**BEFORE THE PUBLIC UTILITY COMMISSION**

PACIFICORP, dba PACIFIC POWER,

2019 Integrated Resource Plan.

Final Comments

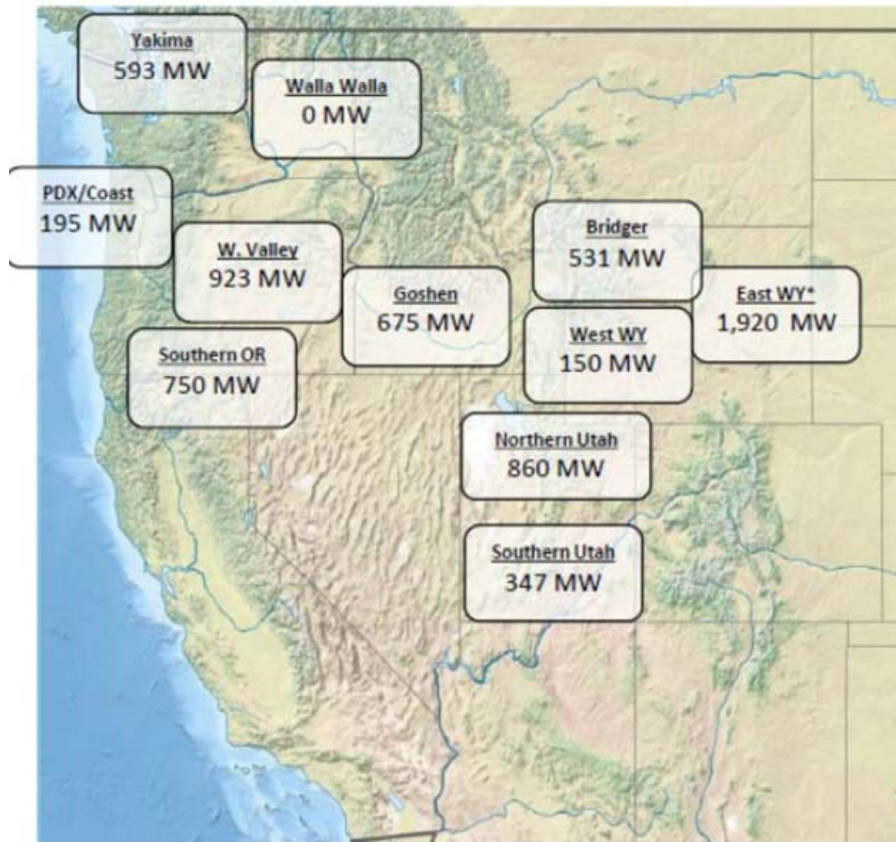
Additionally, Staff questions whether EGS is truly a least-cost, least-risk resource for ratepayers in the action plan timeframe. Staff has performed analysis showing that delaying EGS until 2030, which is the next year of significant wind investment in the preferred portfolio, would save ratepayers approximately \$355 million in Net Present Value Revenue Requirement (NPVRR) through deferral of depreciation, interest, and taxes. Every year that EGS can be delayed will increase the savings to ratepayers substantially, and even in 2030, it appears that PacifiCorp may have enough interconnection capability to connect about 1,000 MW of new generation without building EGS.<sup>1</sup>

Figure 4.1 - Load and Coincident Peak Load Compound Annual Growth Rate 2019-2028

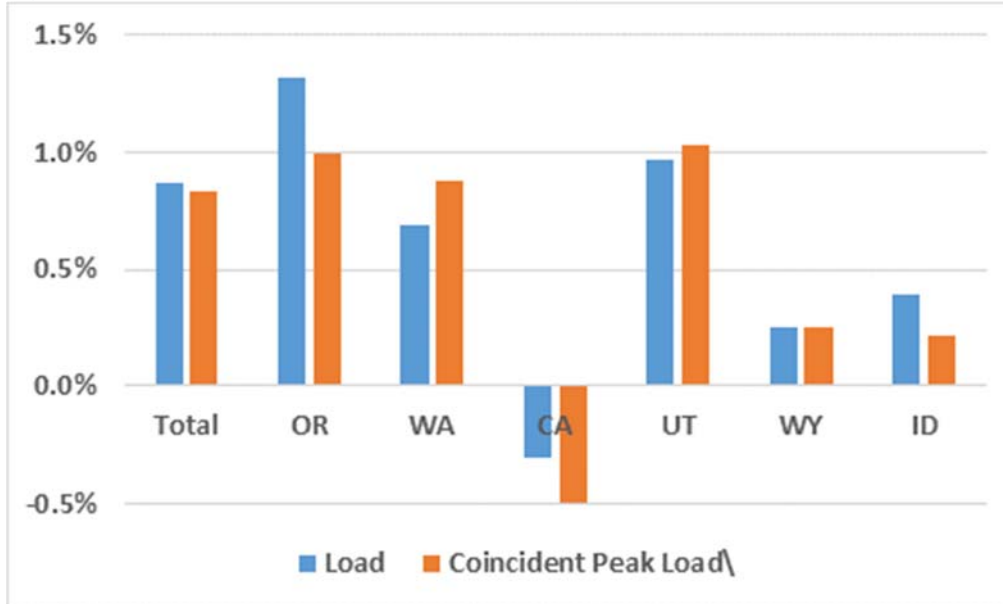
If that is the case, Staff finds it curious that while the growth in coincident peak load has similar patterns from state to state, this did not result in more demand response selection in Oregon. The next figure and table compare the growth in load to the growth in coincident peak load by state. The trends in coincident peak loads by state are similar to the trends in load.

While this information does not refute the possibility that energy efficiency choices by state should be driven by expected load growth by state, it does point to some inconsistency in how demand-side resources are chosen at the state level, and further supports Staff’s assertion that demand response is under-selected in Oregon.

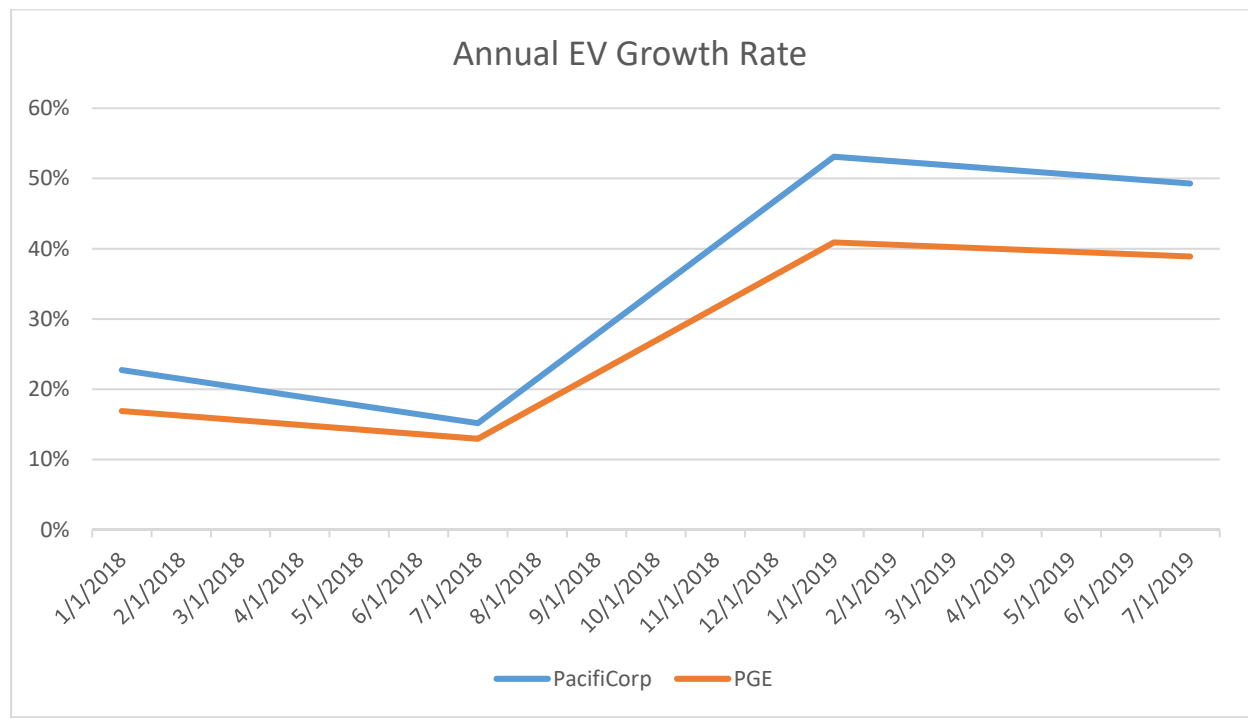
PacifiCorp asserts future demand from electric vehicles is present in the historical data. In the Company's reply comments, PacifiCorp states:

With respect to transportation electrification in the load forecast, the company did not explicitly incorporate a forecast of electric vehicles (EV) into the 2019 IRP. However, EV load is currently captured and reflected in the load forecast that informs the 2019 IRP because historical sales to EV owners inform the actual sales used within the load forecast. Thus, the load forecast used for the 2019 IRP development projects EV adoption consistent with observed historical EV adoption throughout the company's service territory.<sup>54</sup>

The observed growth of electric vehicle (EV) adoption in PacifiCorp's Oregon territory cannot be reasonably expected to find a signal from this historical data if future EV loads do not resemble past

Figure 4.2 – “The Triangle” without Gateway South

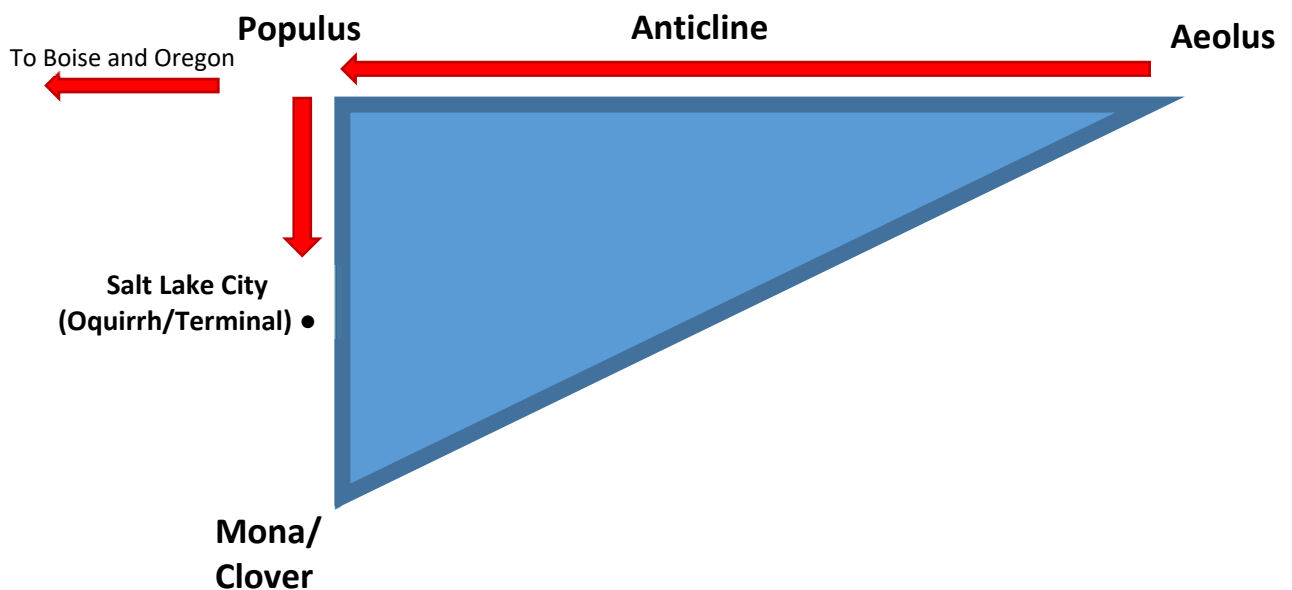
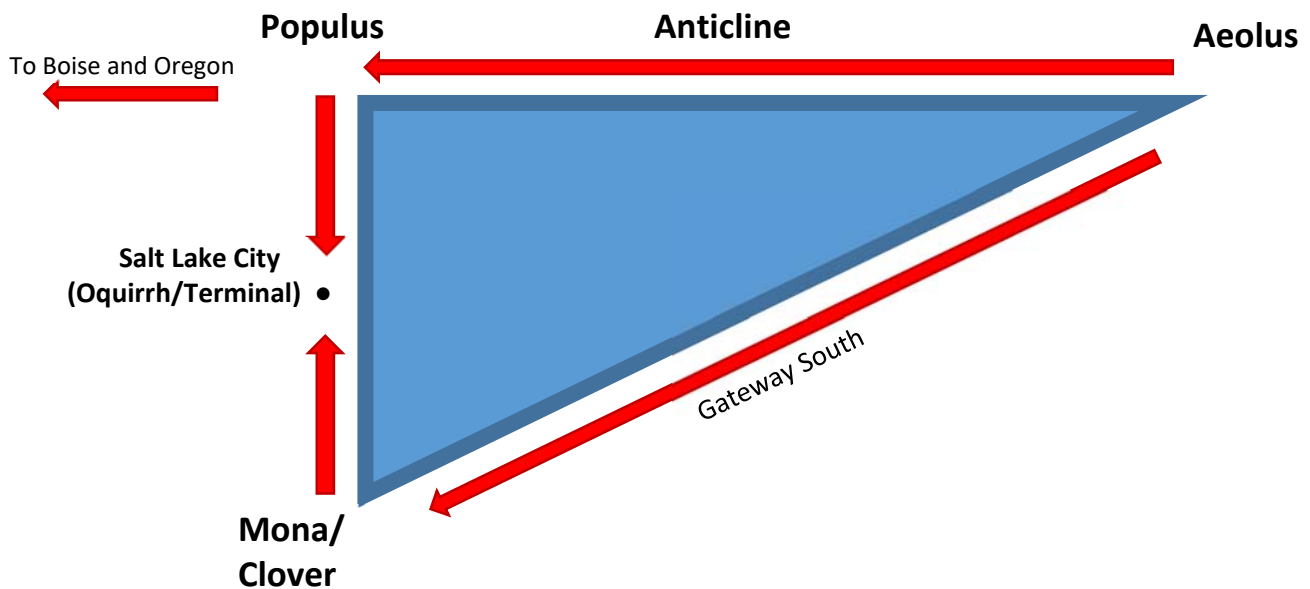
In Initial Comments, Staff raised the issue of the value of Gateway South to Oregon customers.<sup>68</sup> In its Reply Comments, PacifiCorp stated that the Gateway South Project increases the reliability of the central Utah transmission system while also supporting the significant transfer capability of the Energy Gateway South Project.<sup>69</sup> Below are very simplified graphics demonstrating basic topology of Gateway South and associated transmission flow in the region. Aeolus-to-Anticline is the line segment D.2, which will be completed this year and will enable an additional 950 MW of transfer capability. Anticline-to-Populus is segment D.3, which has not been constructed. The line pointing South from the Populus substation to Salt Lake City is Populus to Terminal (Segment B of Gateway Central), which was energized in 2010. There is also an existing line from Mona to Oquirrh (Segment C of Gateway Central), also represented by Salt Lake City, and this was energized in 2013. The red arrows indicate power flows.

In Opening Comments, Staff pointed out that the selection of Gateway South is tied to the production tax credits. That is, the economics favors the wind, but Gateway South is needed to facilitate interconnection and flow of the wind because without it, the system would suffer contingencies. In other words, the current transmission system cannot support the additional 1,920 MW of wind, which is what System Optimizer selects. However, as the graphics show, Gateway South will also reinforce Utah load. *Figure 4.3* demonstrates that additional power can get to Salt Lake City via Gateway South, the new wind, and the already existing path that consists of Segment C, Mona to Oquirrh.

Figure 4.4: Comparison of Historical PG Adoption Trend to 2019 IRP PG Forecast<sup>89, 90</sup>

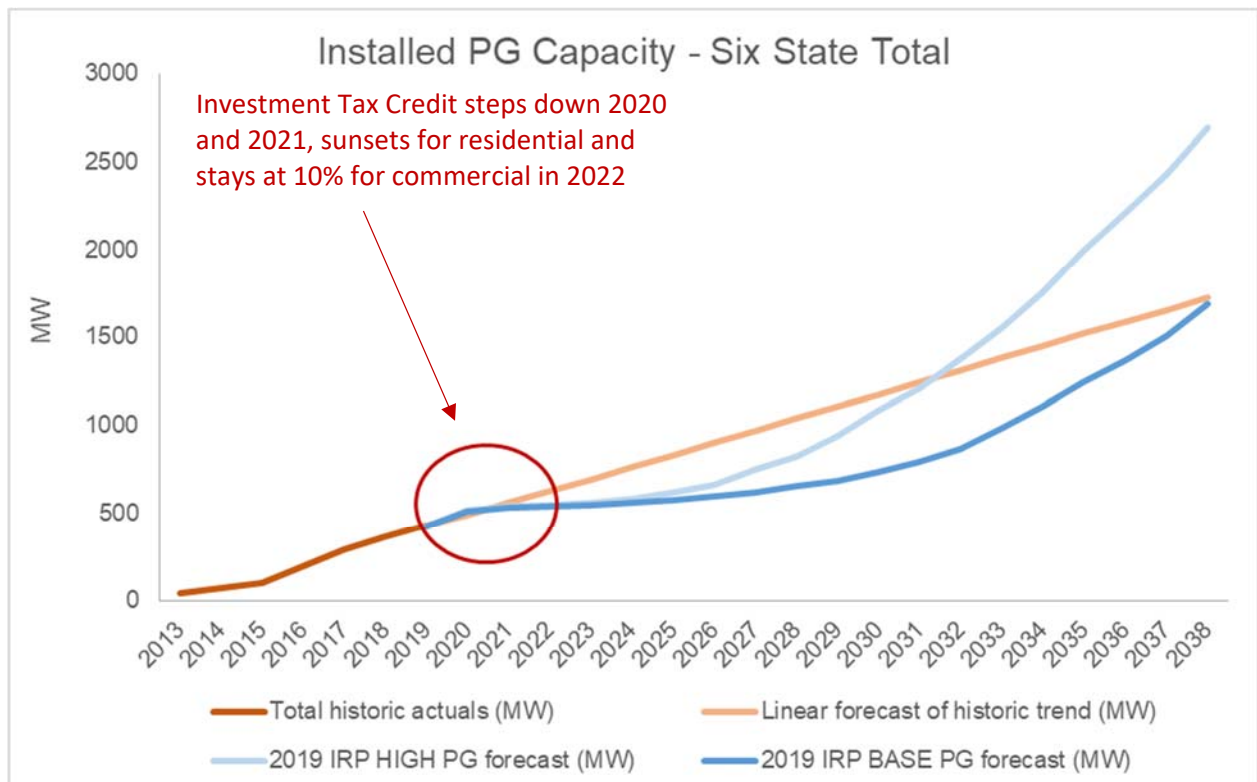
These and other economic drivers result in the PG forecast shown in Figure 4.4. While the base and high PG forecasts project a similar or higher level of PG adoption by 2038, Staff finds both forecasts are likely underrepresenting the contribution of PG resources over much of the planning horizon. Specifically, Staff finds that the base PG forecast is, on average, 22 percent lower than a linear forecast of the recent historic trend.

Staff agrees that, if the ITC sunsets as scheduled, customer adoption is likely to dip for a period of time, but finds that it is not reasonable to expect a 94 percent dip in PG adoption in 2022 that does not recover again for eleven years.
